# Technical Service Bulletin

## 00 - Engine shuts off and/or EPB activates when driver door is opened

46 12 27 2031850/1 November 20, 2012.

**Figure 1.** Old Start-Stop glovebox insert.

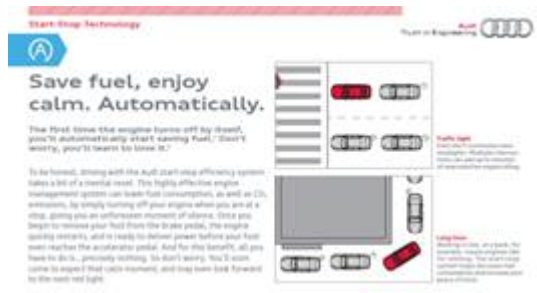
4. If available, replace the old Start-Stop glovebox insert (Figure 1), with the new glovebox insert **BR-12-631-US** (Figure 2). Additional inserts may be ordered from the Brand Store.
